TOWN OF BROOKLINE

PURCHASE ORDER CHANGE FORM

FOR: Driscoll School Renovation

Change Order #	Date	
37	4/4/2024	Various Changes to Contract Work

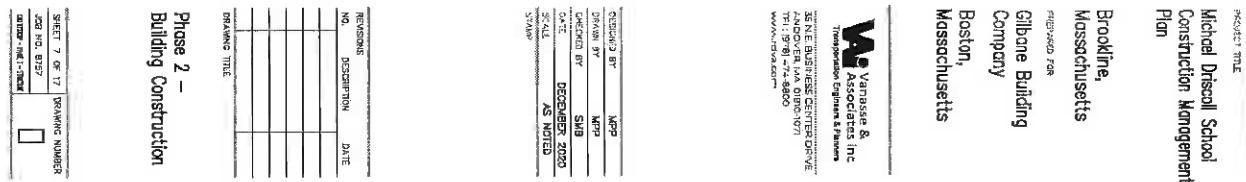
CB23A was installed per the location shown in Contract Drawing C-3.2.

DMH-3 was required to shift within the site fence during deep drain install. JLA comments regarding the SOE are acknowledged but the location of the SOE was dictated by the Project requirement for the Westbourne Terrace sidewalk to remain open during Construction.

## Drainage Structure Conflict with Footing and Wall at Ramp

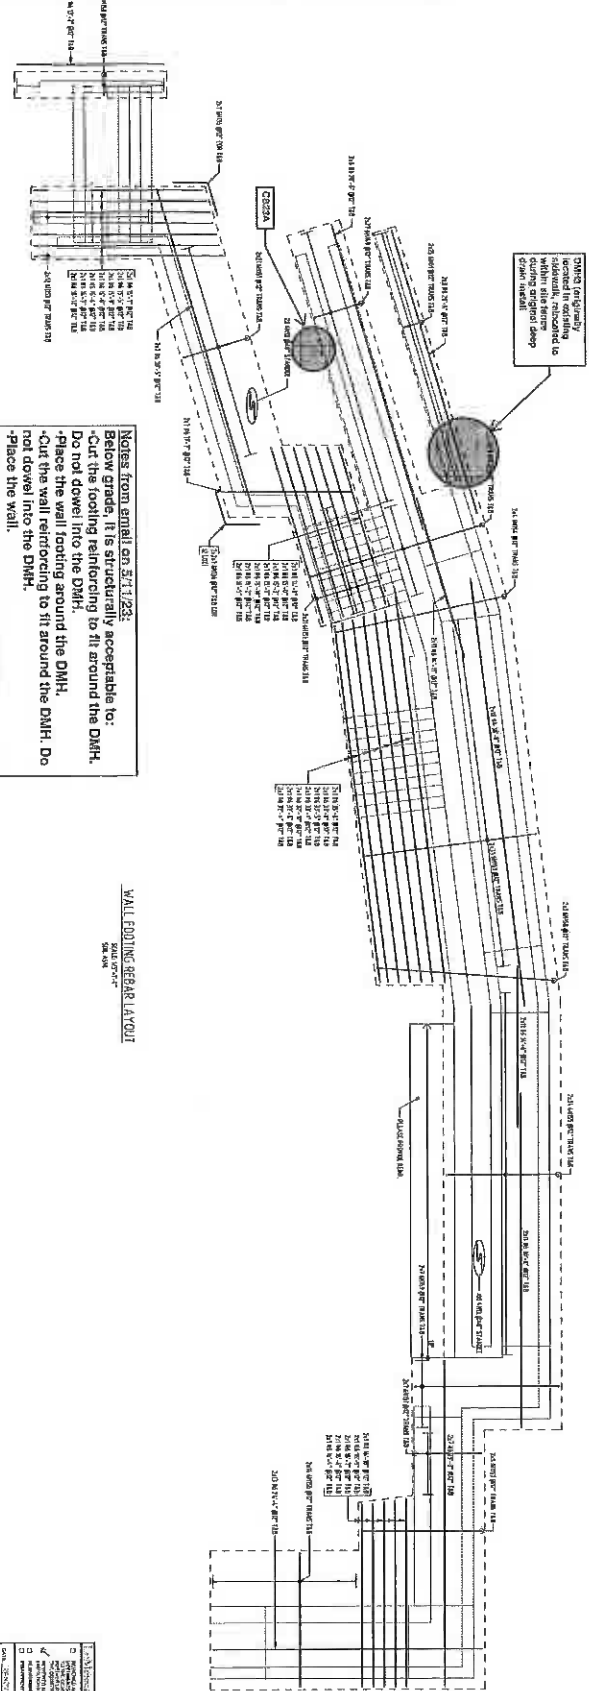
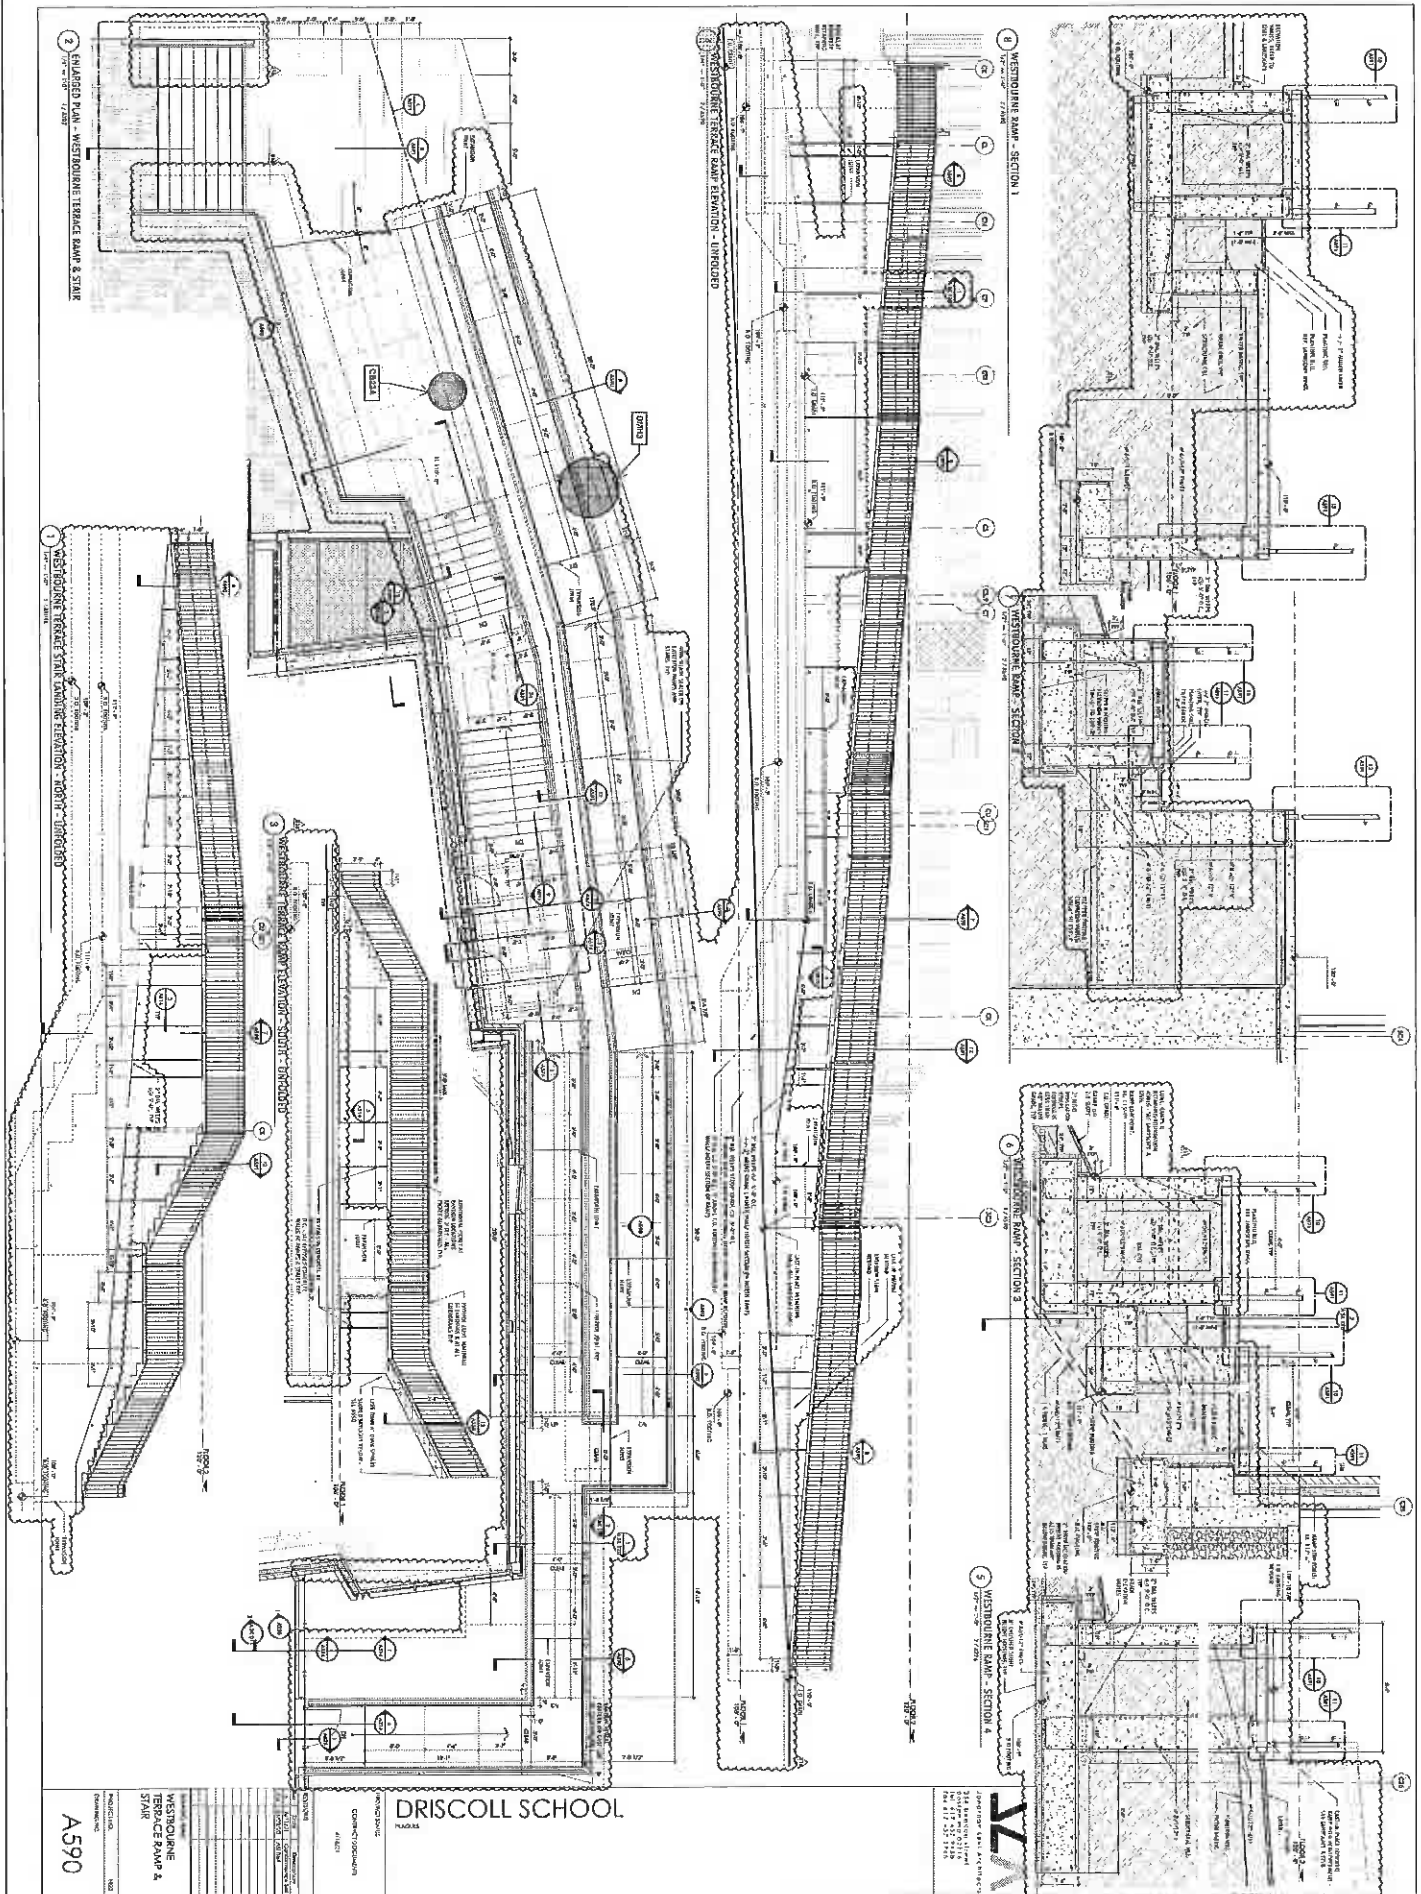
See attached marked up drawings and photo regarding the drainage structure conflict with the wall and footing as shown marked up on R8.01 and A590.

As discussed, below grade, it is structurally acceptable to:

- Cut the footing reinforcing to fit around the DMH. Do not dowl into the DMH.
- Place the wall footing around the DMH.
- Cut the wall reinforcing to fit around the DMH. Do not dowl into the DMH.
- Plane the wall.

**Official Response:** Carol Harris (Jonathan Levi Architects LLC) responded on Wednesday, May 17th, 2023 at 4:55PM EDT  
Refer to LeMessurier response attached.
